**The Philadelphia Parking Authority
701 Market Street, Suite 5400
Philadelphia, PA 19106**

**Bid No. 20-19
Proposed Lighting Installation at 6 E. Oregon Avenue
Addendum One**

BACKFILL (TRENCH)

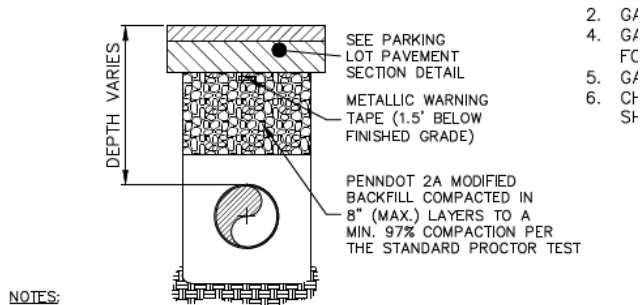
10. **Question:** Is there a detail on patching the asphalt when we trench it to put in the conduit?

Response: Please see the following details for Backfill (Trench) and Parking Lot Pavement Section, all restoration shall be in conformance with these details:
